Illinois Tollway Standard Drawing Revisions

Section H		Roadway Lighting	
Drawing	Modification Summary	Effective: 03-01-2026	
H1-14	LIGHT STANDARD FOUNDATION		
Sheet 1	Alternate anchor bolt detail added.

LIGHT STANDARD - TRUSS ARM
 (DUAL TRUSS ARM SHOWN, DUAL MAST ARM SIMILAR)
 N.T.S.

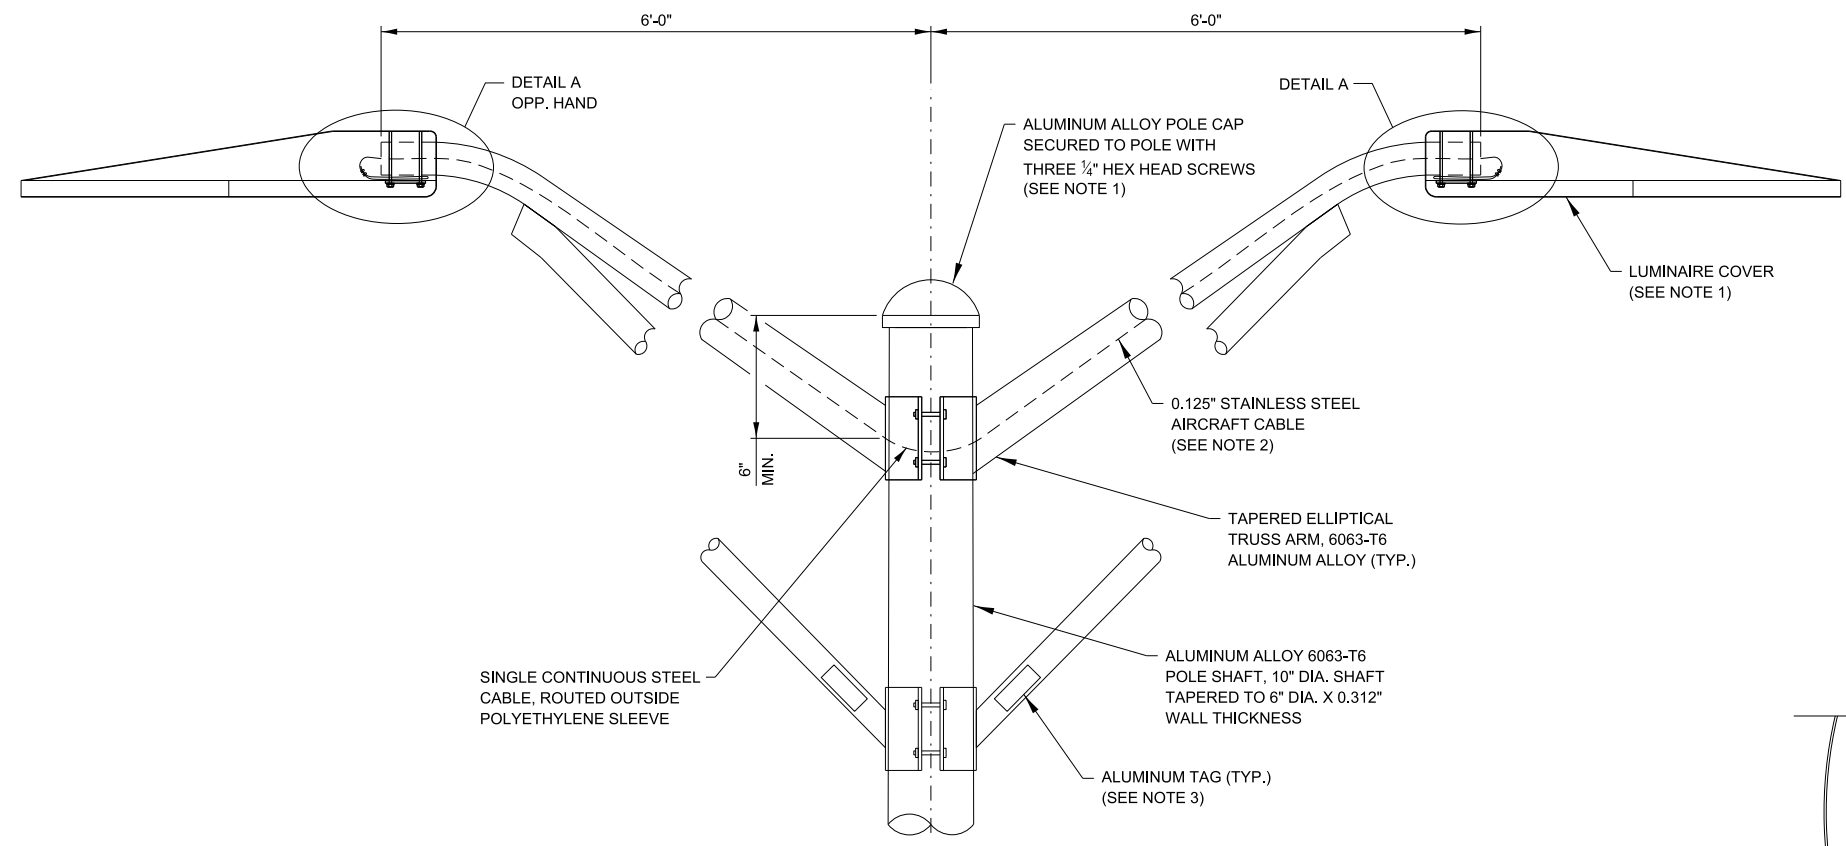
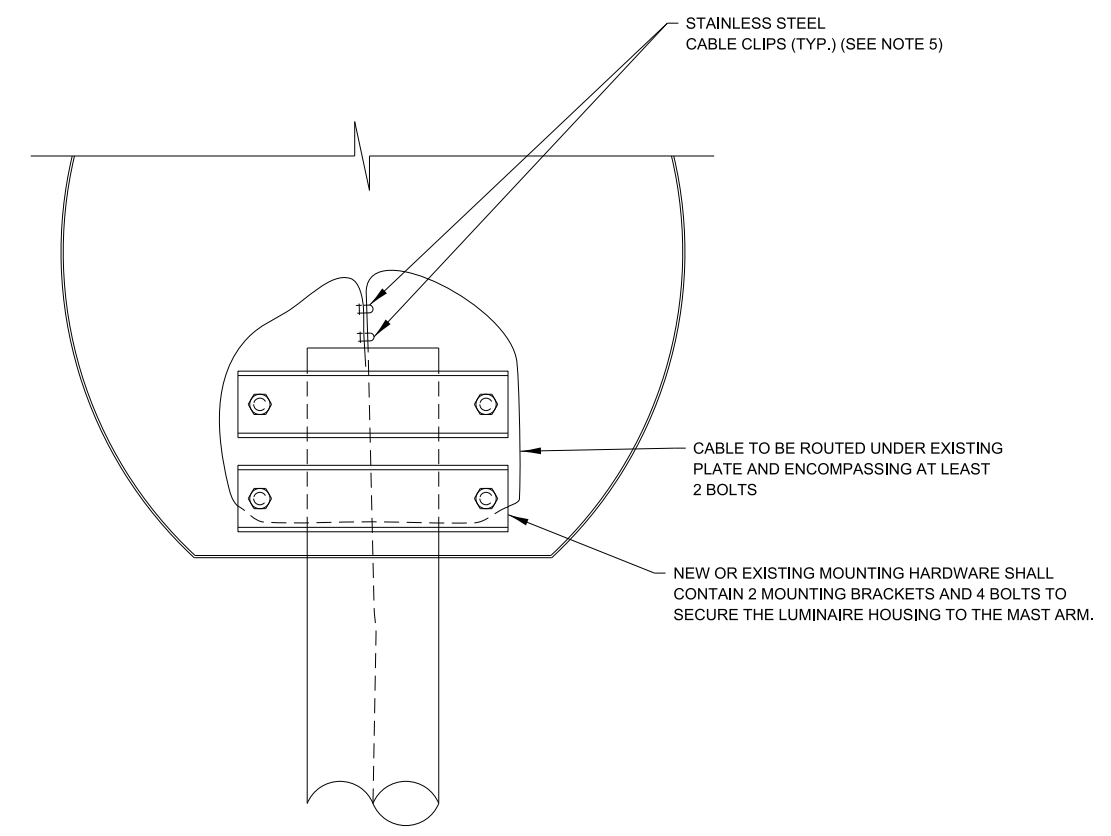
REVISIONS	
DATE	DESCRIPTION
03-01-2026	REPLACED "TWIN" MAST ARM WITH "DUAL" MAST ARM. REVISED NOTE 3.
03-01-2024	ADDED DETAILS REGARDING THE HARDWARE USED TO SECURE THE LUMINAIRE HOUSING.
03-01-2020	REVISED BRACKET AND ROUTING DETAILS.

MAST ARM CABLE ASSEMBLY (SINGLE MAST ARM)

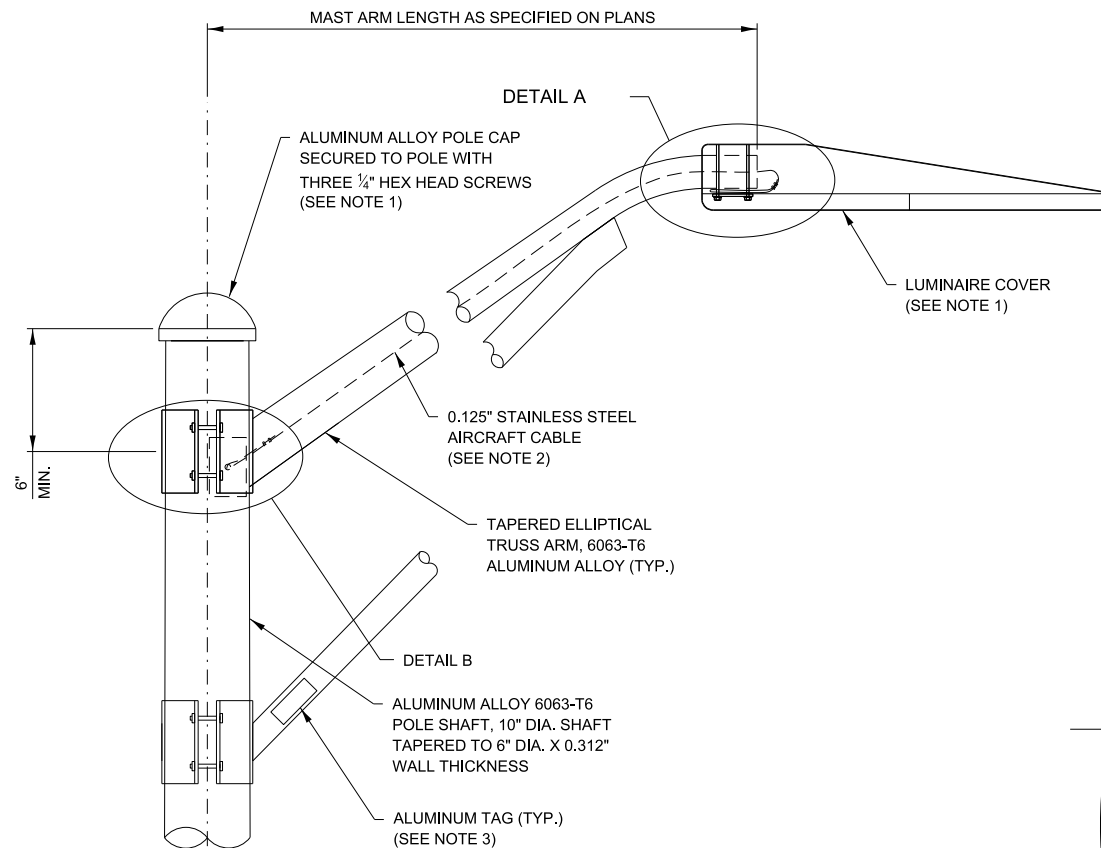
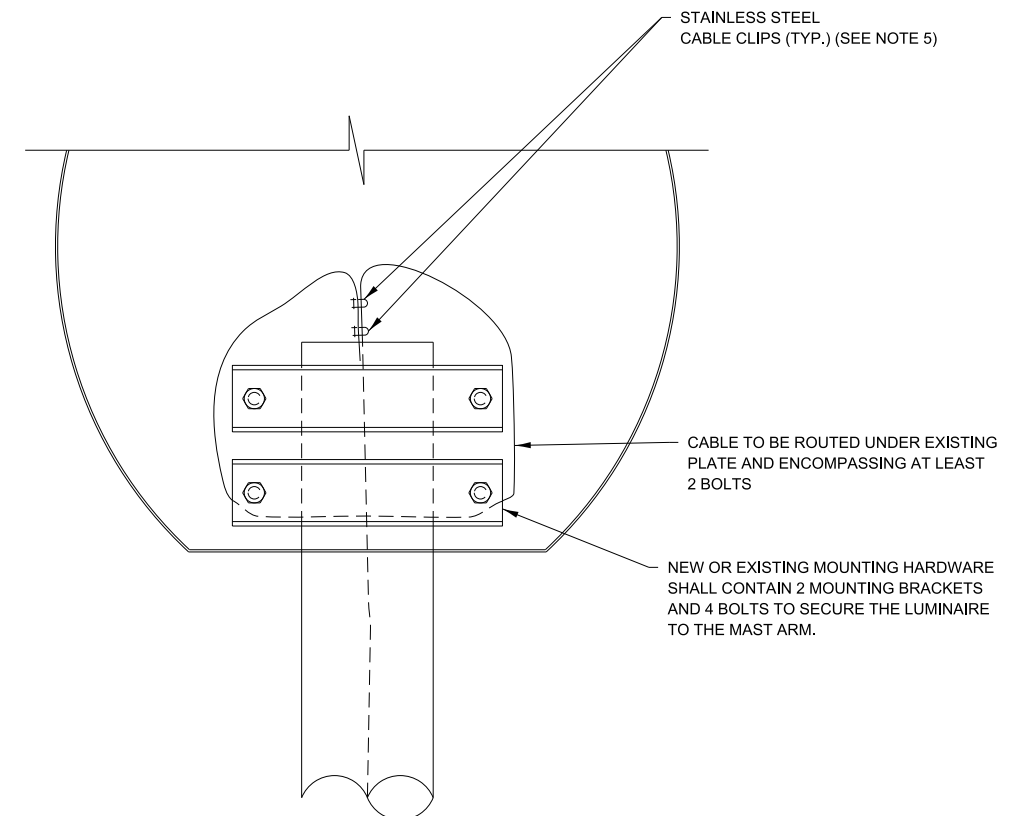
REVISIONS	
DATE	DESCRIPTION
03-01-2026	REVISED NOTE 3.
03-01-2024	ADDED DETAILS REGARDING THE HARDWARE USED TO SECURE THE LUMINAIRE HOUSING.
03-01-2020	REVISED BRACKET AND ROUTING DETAILS.

PARKING LOT LIGHT FOUNDATION DETAILS

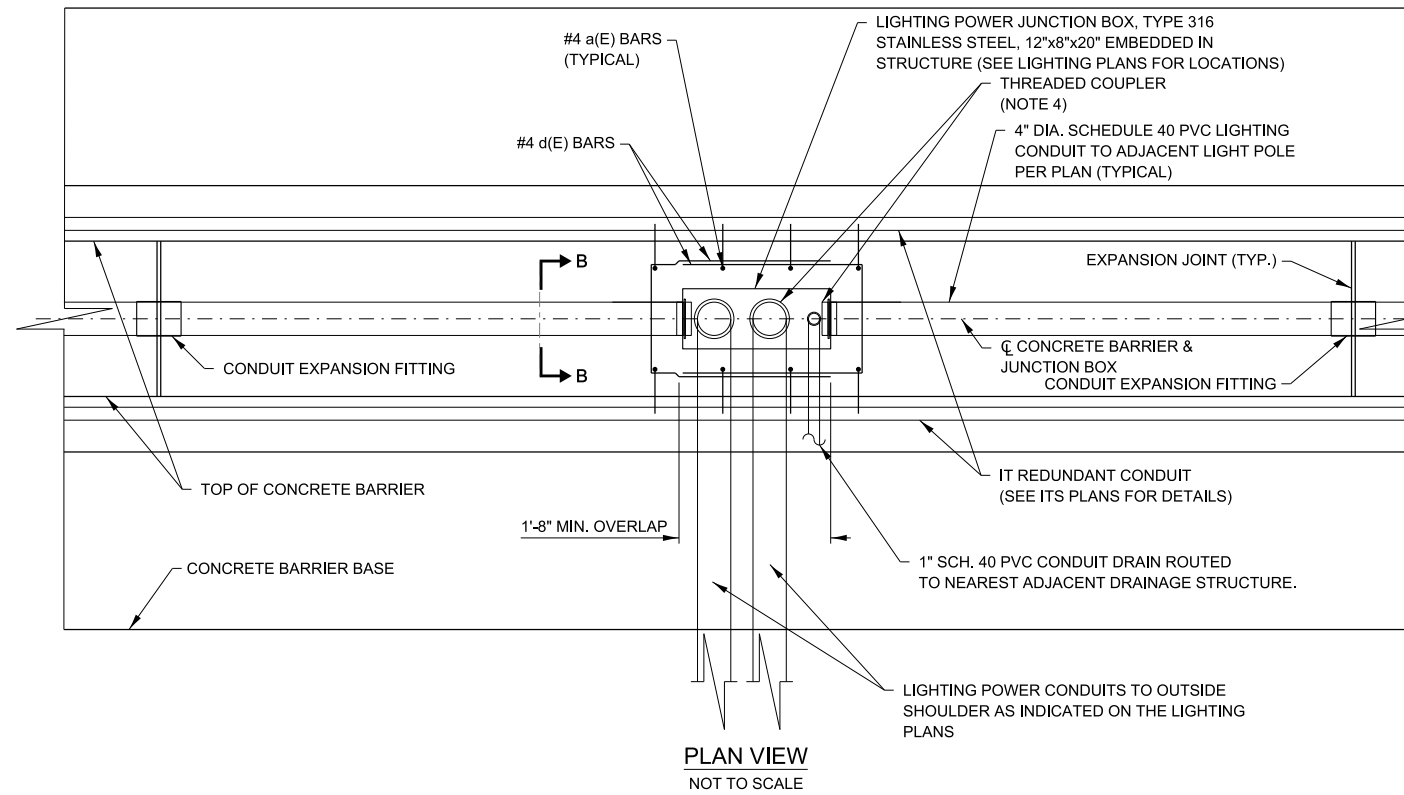
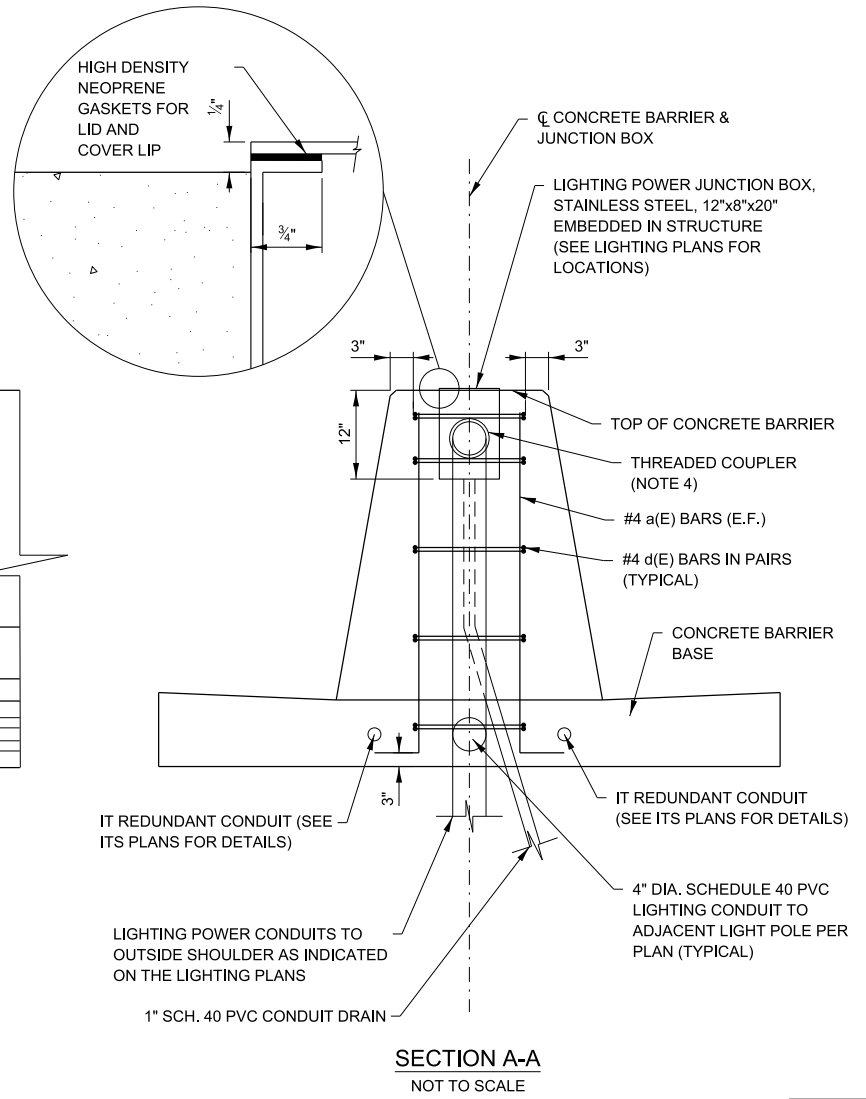
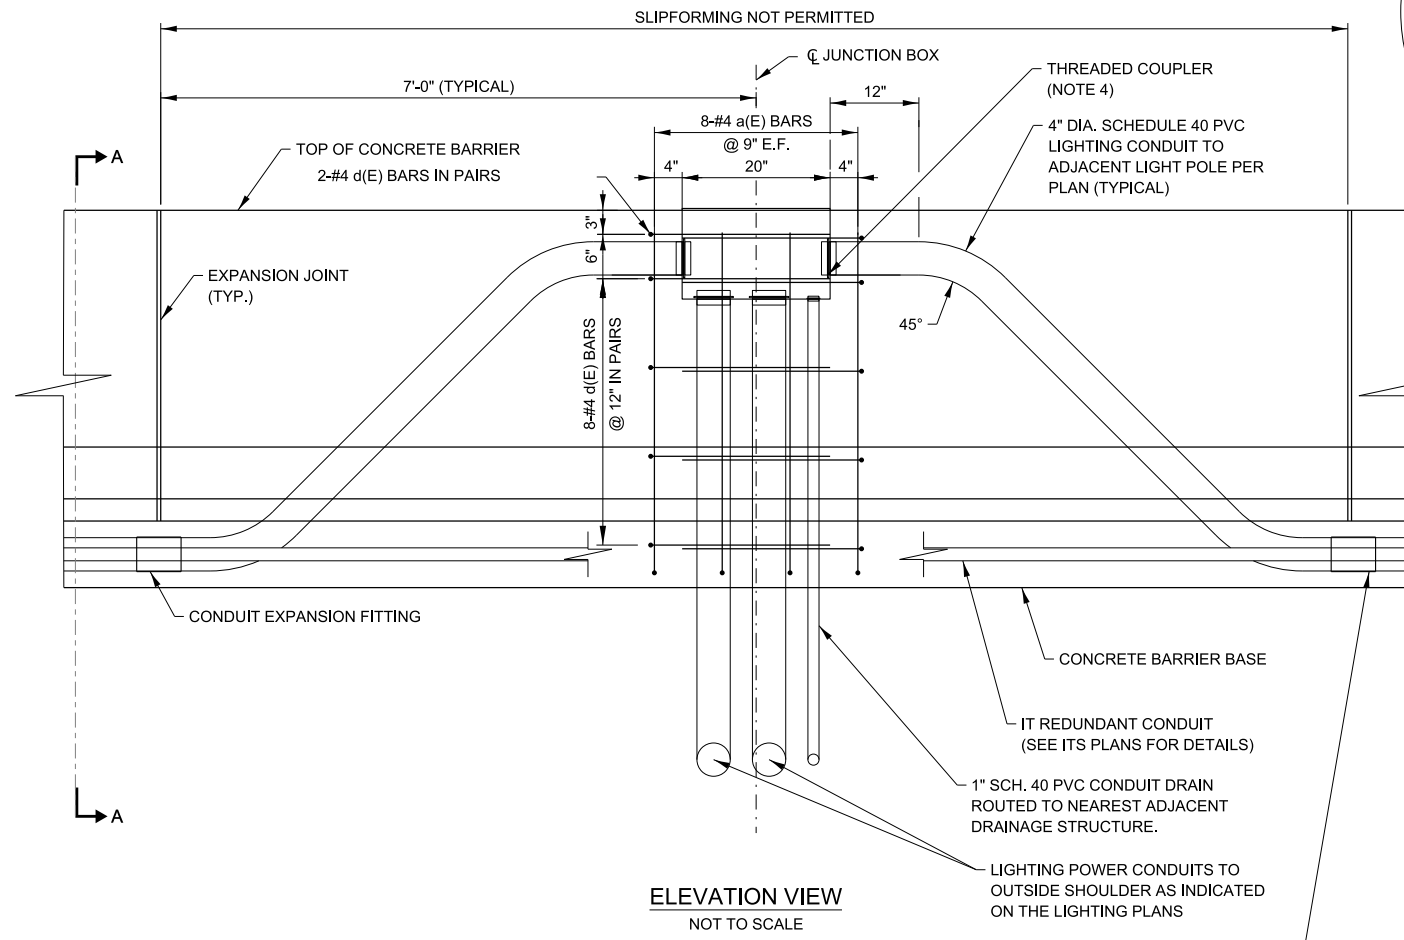
REVISIONS	
DATE	DESCRIPTION
03-01-2026	ALTERNATE ANCHOR BOLT DETAIL ADDED.
03-01-2023	REVISED v1(E) BARS FROM #6 TO #8
03-01-2022	INCREASED ANCHOR BOLT PROJECTION
